##### **Application of the Convention – Vehicles with sliding sheets**

### **Vehicles with sliding sheets**

#### **Note by the secretariat**

##### Sketch No. 10.1

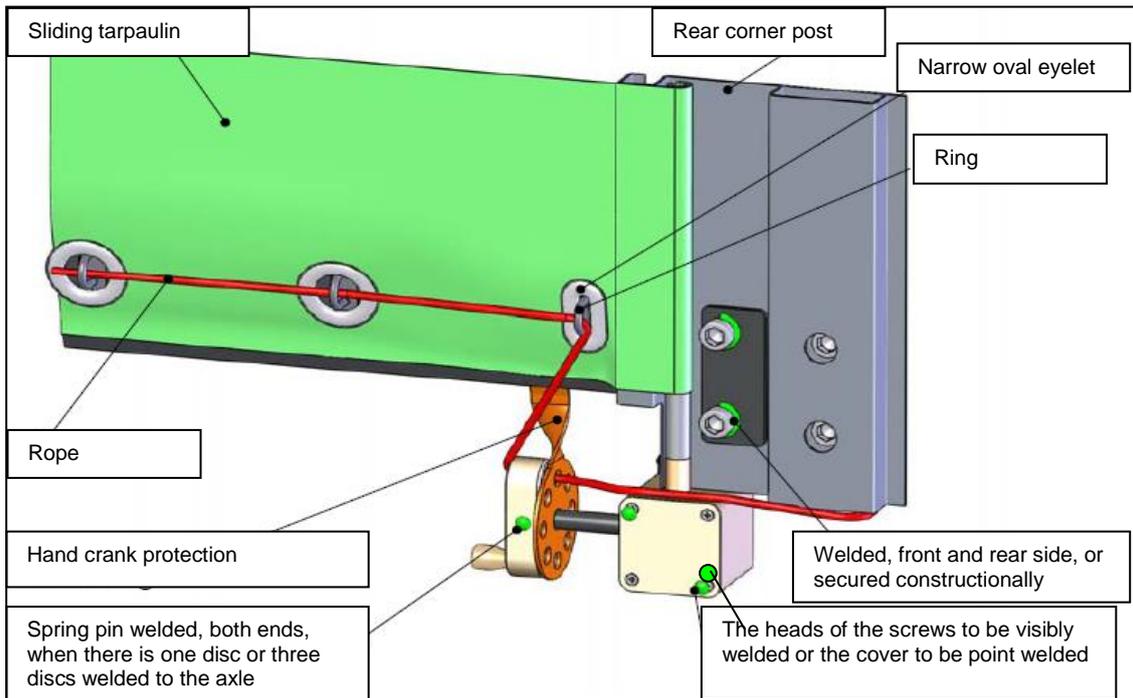
The place where the draw-bar/tensioning bar connects to the square axle exiting the ratchet system **MUST** be covered and protected by a metal-plate, and this plate **MUST** be secured by the rope/TIR wire. The square axle exiting the ratchet system is normally between 15 and 20 mm high and it is possible to force the draw-bar/tensioning bar off the axle – a big screwdriver and a few pushes is enough.

**LEFT:** Ratchet release system – note the height of the square axle: 20 mm only!

**RIGHT:** Alost similar ratchet system – lock system for the handle secured by the rope/TIR wire + metal-plate covering the connection of the draw-bar/tensioning bar secured a system of eyelets, TIT rings and the rope/TIR wire.

(b) Gearbox securing

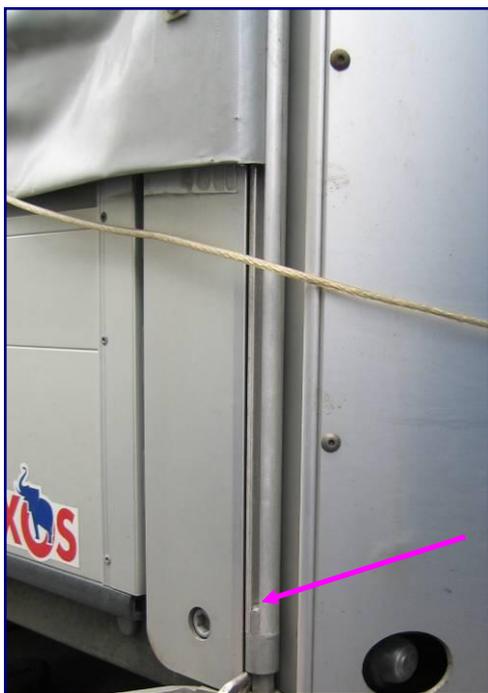
Arrow pointing at a single plate mounted in order to prevent rotation of the hand crank. It is quite easy to force this single plate away from the handle making 6-8 mm space between the hand crank and the plate – which makes it possible to rotate the handle. It is ALWAYS possible to find extra (loose) 15-25 cm of rope (TIR-wire), especially where the customs seal is affixed. The system preventing the handle to be rotated MUST consist of a 3-plate system – as illustrated by CLCCR (WP.30 – 2007 presentation).

Oval shows the “brass” end-piece connection to the square axle from the gearbox and the visible end (app. 6-8 cm) of the “hollow” draw-bar/tensioning bar. The sheet/tarpaulin can easily “slide” up-down inside the draw-bar.

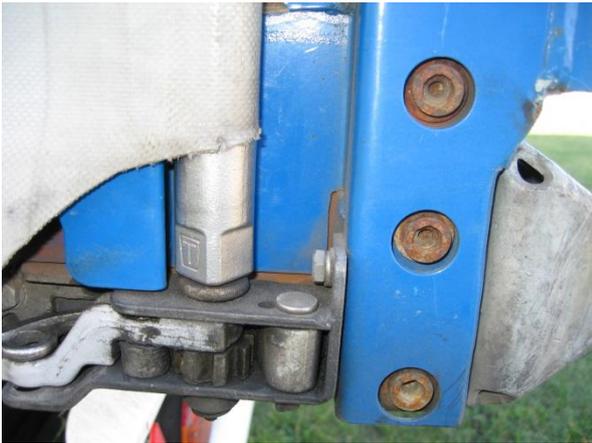
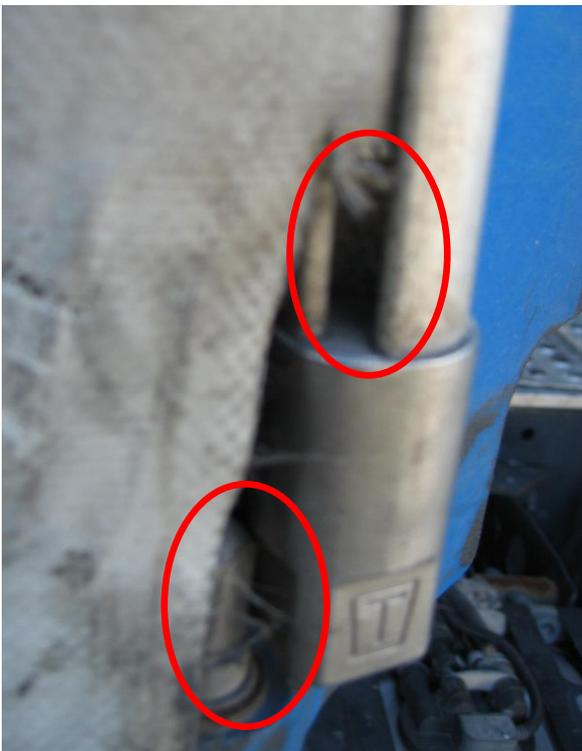
Photo of the “hollow” draw-bar on a vehicle with sideboards and sliding sheet. The draw bar can easily move up-down as the sheet is not fixed to the bar – quite big open slid in the draw-bar.

It is quite easy to lift the draw-bar off its base – also if it is pulled tight. The most difficult part is to reinstall. Often a special prepared pipe wrench or tong is required, and I have only once seen this adapted wrench unfortunately I have no photo available. If the slid is visible it is possible to use the top of the end piece to force the draw bar back in place (arrow).

Picture of an end-piece with square lower part. This end-piece (and draw-bar) can easily be rotated by using a normal wrench. Also the opening where the sheet is inserted in the draw-bar is accessible. Note the gap between the sheet and the end-piece (app 2,5 cm) – the sheet can slide this distance inside the draw-bar.

Same type of end-piece – located at the REAR of the trailer.

Note the slid / space between end-piece and sheet – it is equal to the height of the square base for the draw-bar. This allows for movement the draw-bar – up/down.

**Sketch No.10.2**

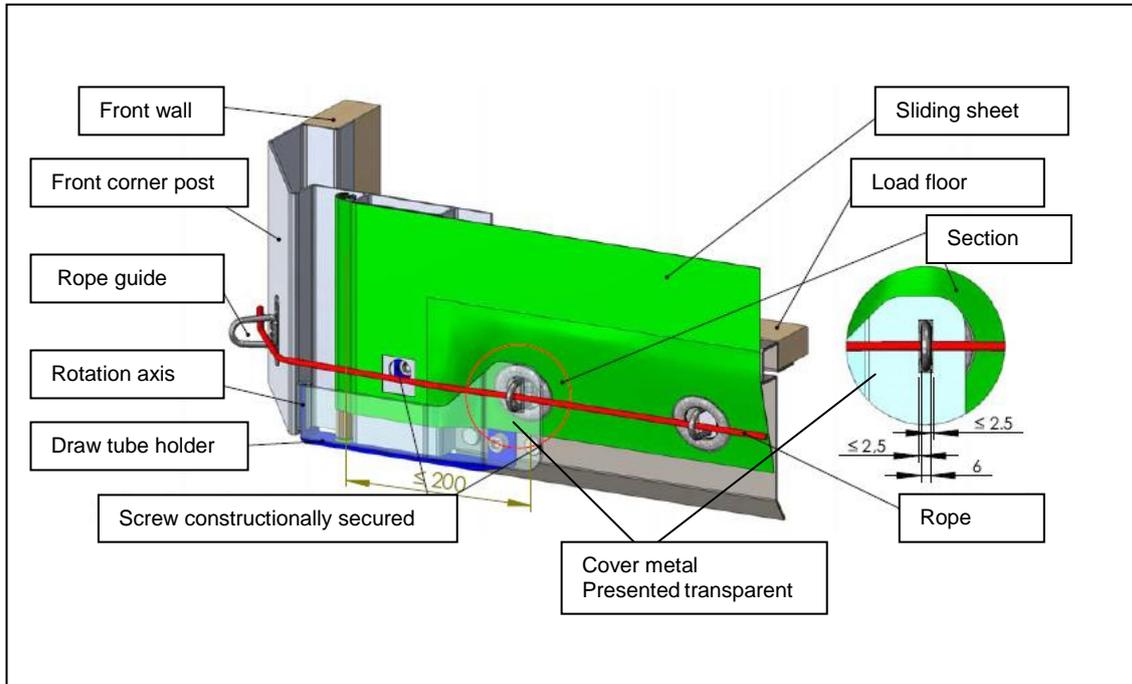
**The system above I consider being secure – due to the metal plate covering the base and end-piece of the draw-bar. There is no access for tools needed to lift off the bar.**

- (b) Narrow oval eyelet, anti lifting system for the tensioning tube

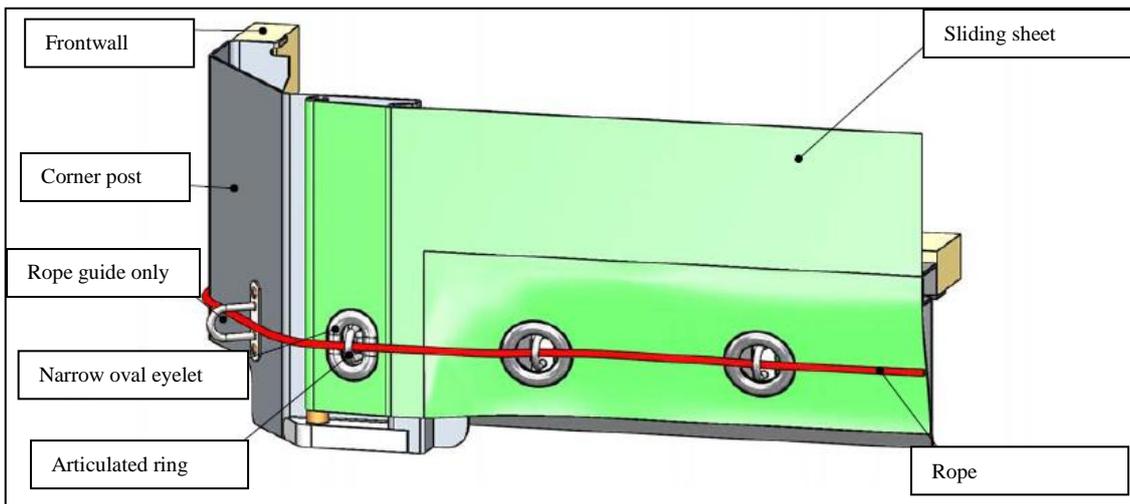
**Although an eyelet/TIR-ring is located quite close to the draw-bar, I still consider this system to be non-secure. There is access to the base for the draw-bar – and bearing in mind that the sheet can slide inside the hollow draw-bar the bar can be lifted (forced) off the base. Again the difficult part is to put it nicely back again (tighten the sheet).**

Sketch 10.3

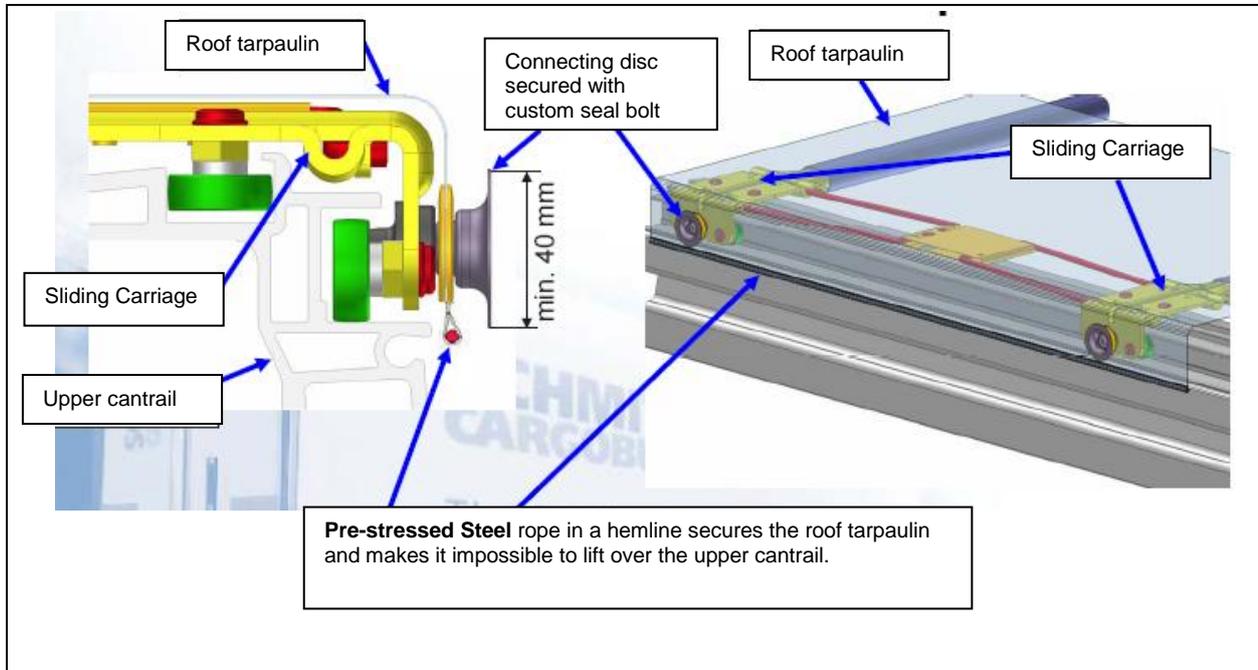
Most sliding roofs are seen having only wheels at the side of the carriage – and this new system is an improvement. The carriage is significantly stronger and better due to the system of wheels both at the upper part and at the side of the cantrail.

However it is a **MUST** that it is not possible to put a hand through and behind the sheet (behind the pelmet covering the sheet along the side of the vehicle). The system above shows the normal distance between the upper crossbars (main carriages) – no additional rollers/bearings mounted, and I am convinced that it is possible to get a hand inside the vehicle. Again I have to refer to the vehicles presented by CLCCR – on this trailer two additional wheels/bearings is mounted to the sheet at the upper cantrail – see photo below.

**Green = Main carriages – seen from outside under the pelmet – distance app. 60 cm.  
Purple = TWO additional wheels/bearings.**

**The two additional wheels/bearings are preventing a hand to pass.**

**This additional system must most likely also be mounted on the roof tarpaulin/sheet – just over the hemline. On the sketch it is rather difficult to see the actual structure of the upper cantrail and therefore not possible to establish the wideness of the cantrail. Along the side an overlap of the solid parts is required (normally/standard is 15 cm) – ¼ of the distance between the rollers/wheels). The same overlap should also be in place at the roof as the cantrail is considered being “a solid part of the vehicle”.**
